**PRELIMINARY PLANNED
MULTI-FAMILY SUBDIVISION
APPROVAL**

CHARLOTTE-MECKLENBURG PLANNING DEPARTMENT
By Brent Wilkinson 2/9/17

BELMONT APARTMENTS

PRELIMINARY PLAN AMENDMENTS: DECEMBER 2016
ORIGINAL SUBMITTAL DATE: AUGUST 2012

OVERALL SITE

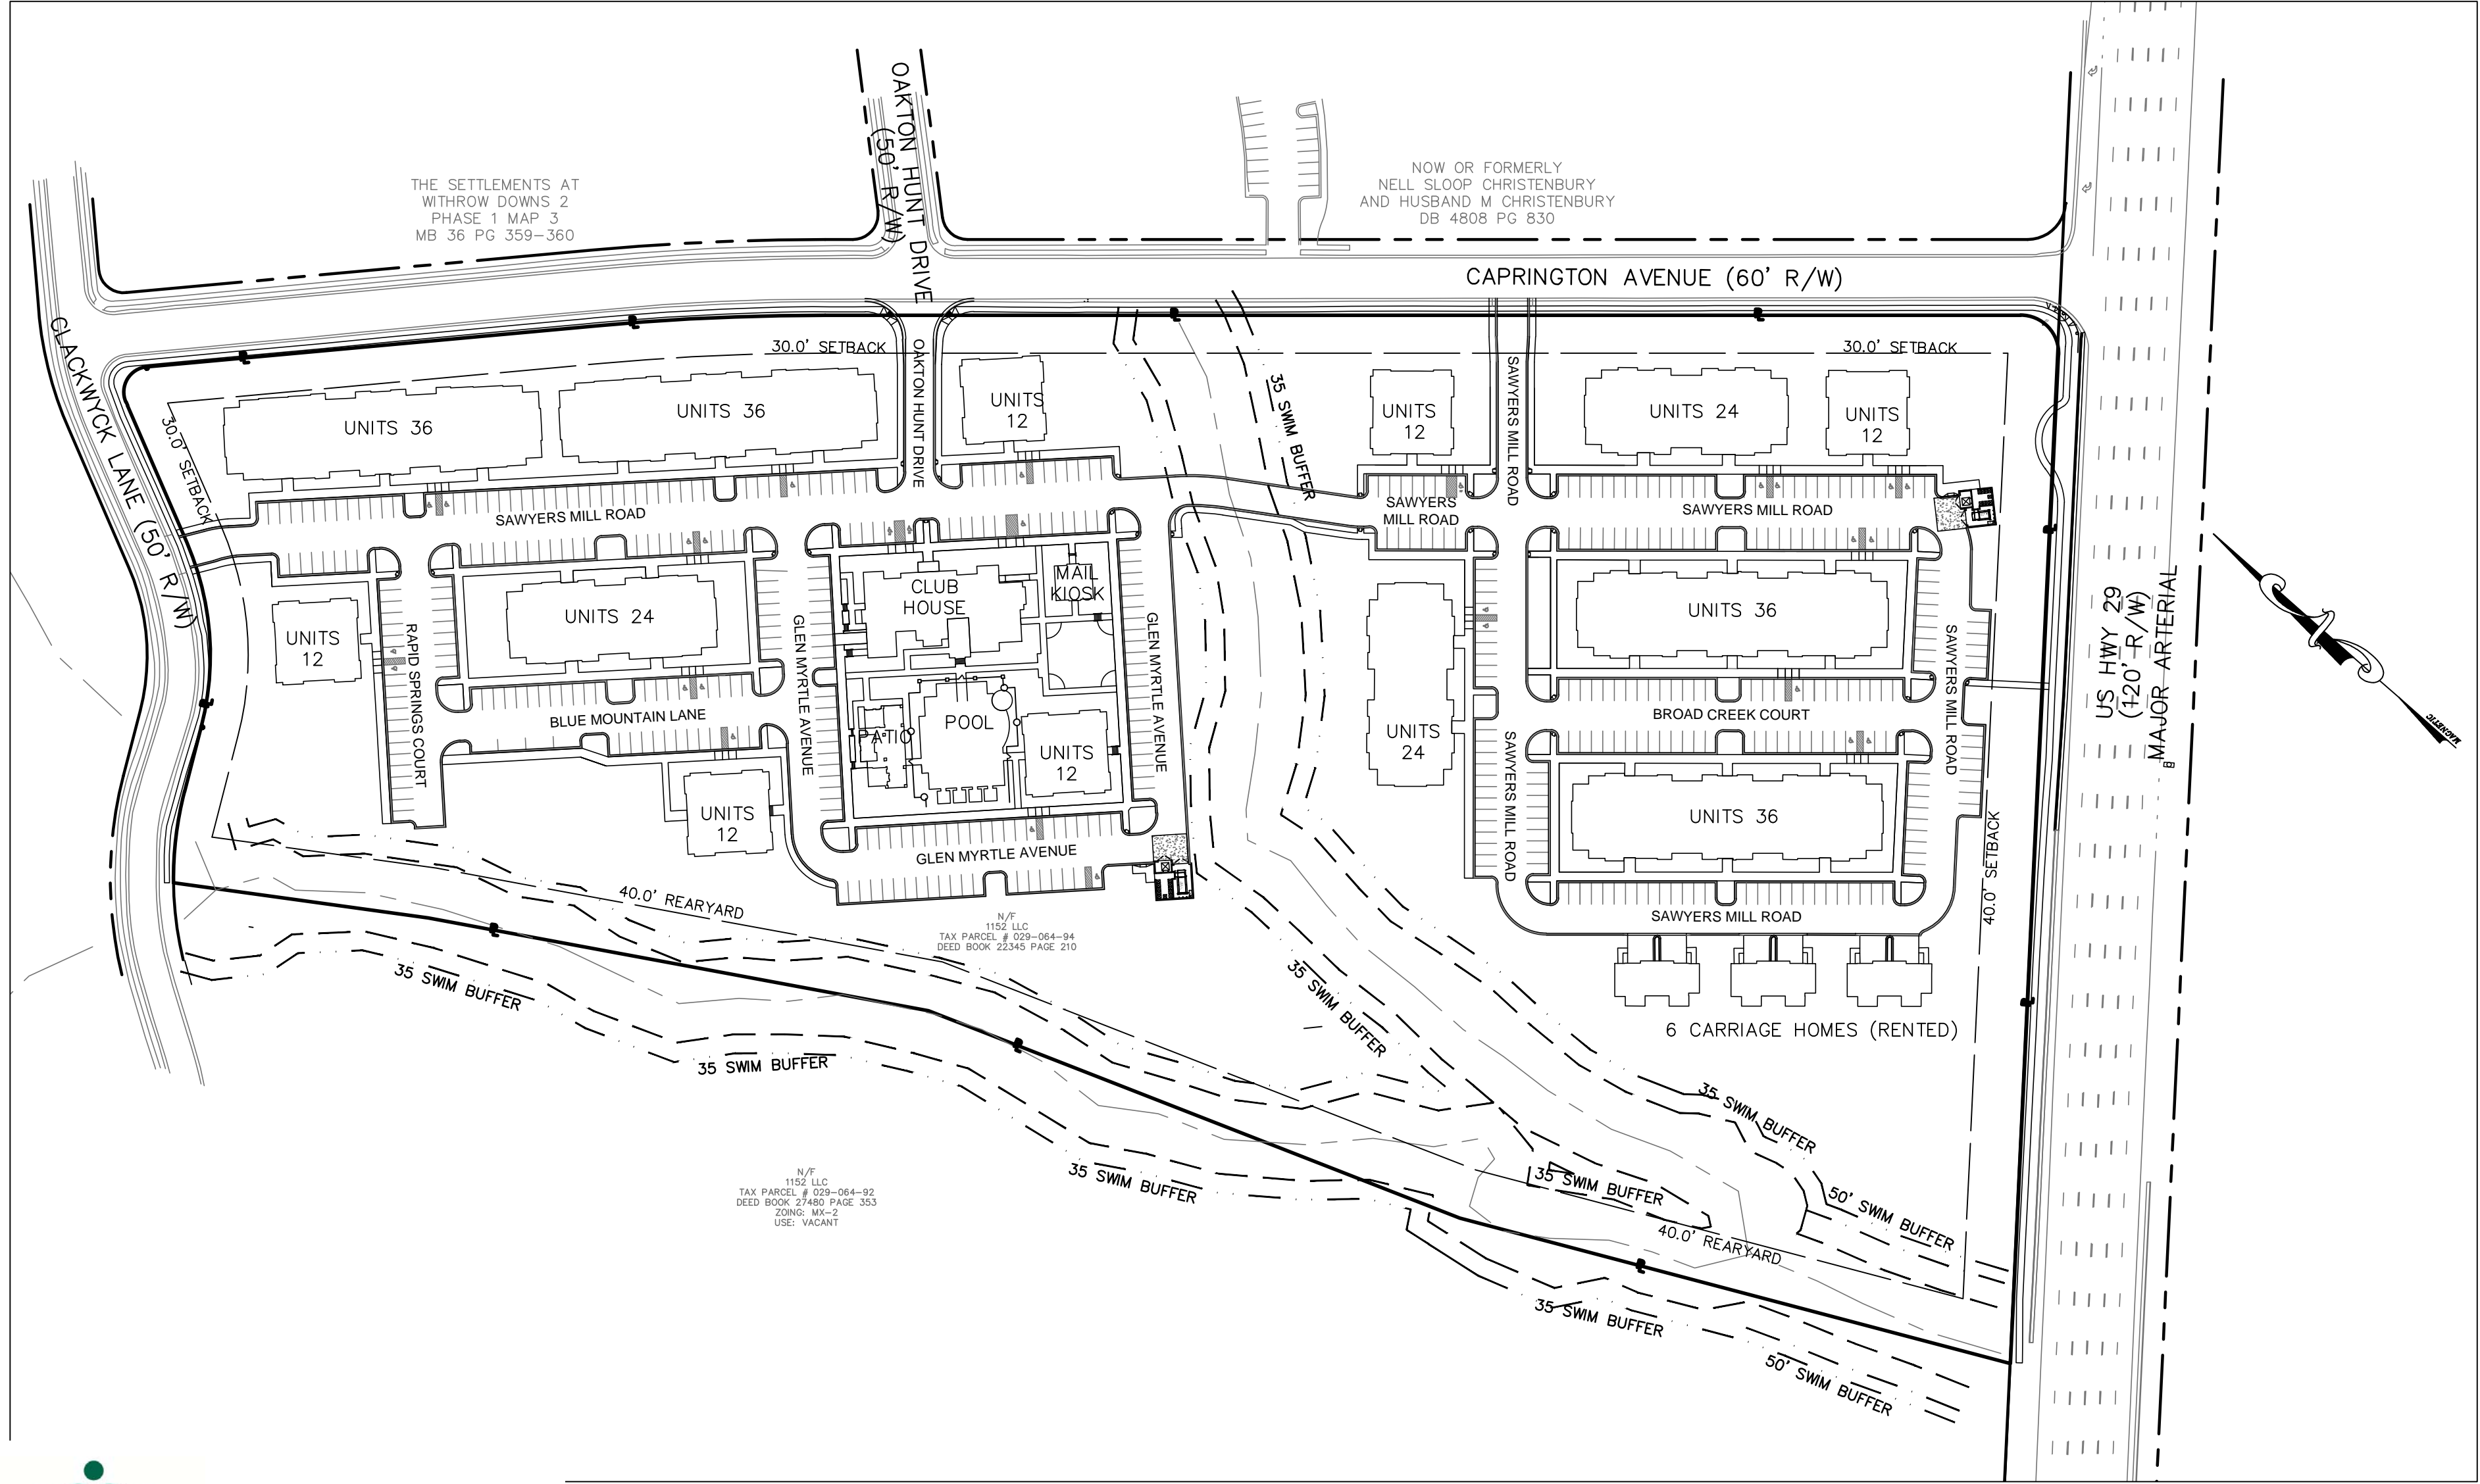
*Original plans approved as revision in 2014 consisted of 14 Apartment buildings and 10 townhomes. Client has revised buildings, eliminated two buildings, replaced 10 townhomes with 6 Carriage Homes. In addition, the Amenities Area has been altered. The new apartment buildings are basically the same footprint as the previous apartment buildings. Only two minor changes to the storm drainage were required and additional spot elevations were added to ensure ADA compliance. This also resulted in relocating a few handicap parking spaces. The total parking count is reduced by two due to the configuration of the handicap parking spaces. The concrete in front of the dumpster pads also increased. The Common Open Space increased due as it replaced much of the area previously shown to be apartment buildings. A more detailed description of the changes related to individual plans sheets is summarized on the cover. Should be noted the sewer relocation was previously completed and the project was platted in 2014. The platting eliminated the need to comply with PCCO requirements established after the project was originally permitted.

FILE NUMBER
CS101-45550004
DRAWING NUMBER
C3.0

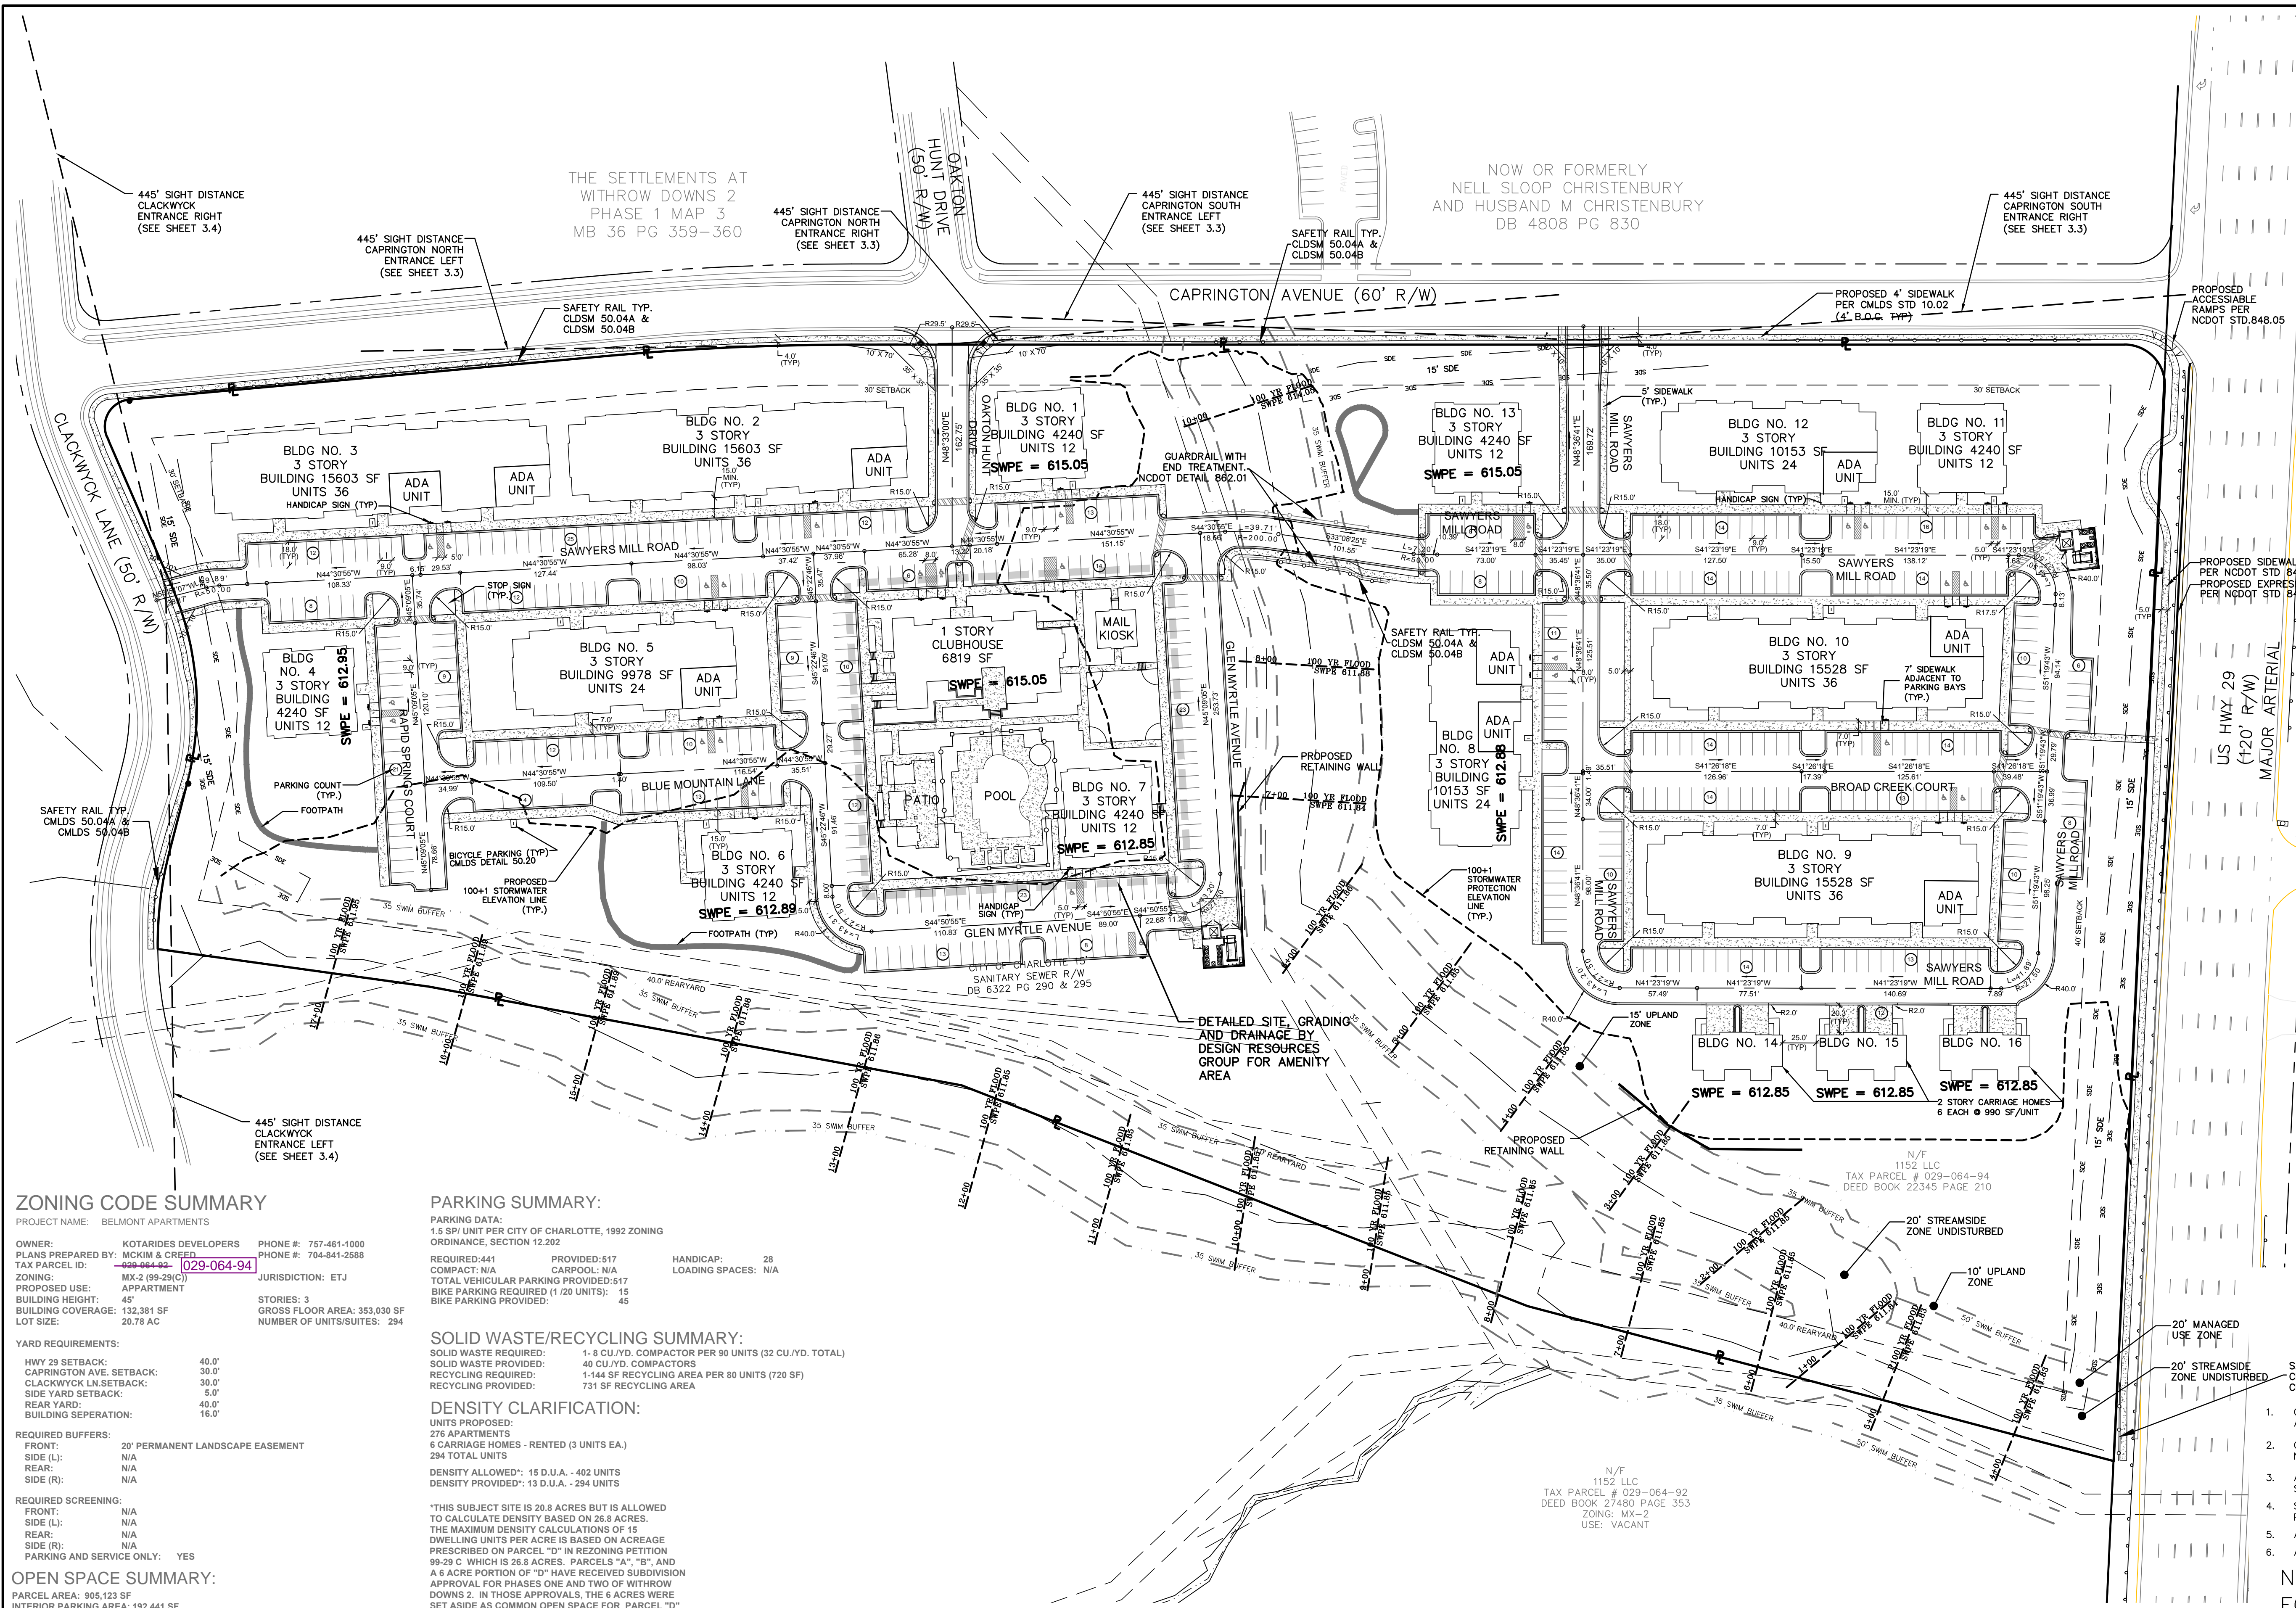
REVISIONS TO THE 2012 APPROVED PRELIMINARY PLANS ARE PROVIDED TO UPDATE OLD BUILDING FOOTPRINTS TO MEET NEW BUILDING CODE REQUIREMENTS, MORE ADA PARKING SPACES AND SPOT ELEVATIONS TO MEET ADA AND FAIR HOUSING, AND ADJUSTMENTS TO UTILITY SERVICES FOR THE NEW BUILDINGS. NO CHANGES TO THE DRAINAGE PLAN, CURB OR ROADWAY LOCATIONS, SEWER, STORM, OR WATER MAINS WERE DONE. TWO BUILDINGS WERE REMOVED AND THE NUMBER OF UNITS AND IMPERVIOUS TOTALS REDUCED.
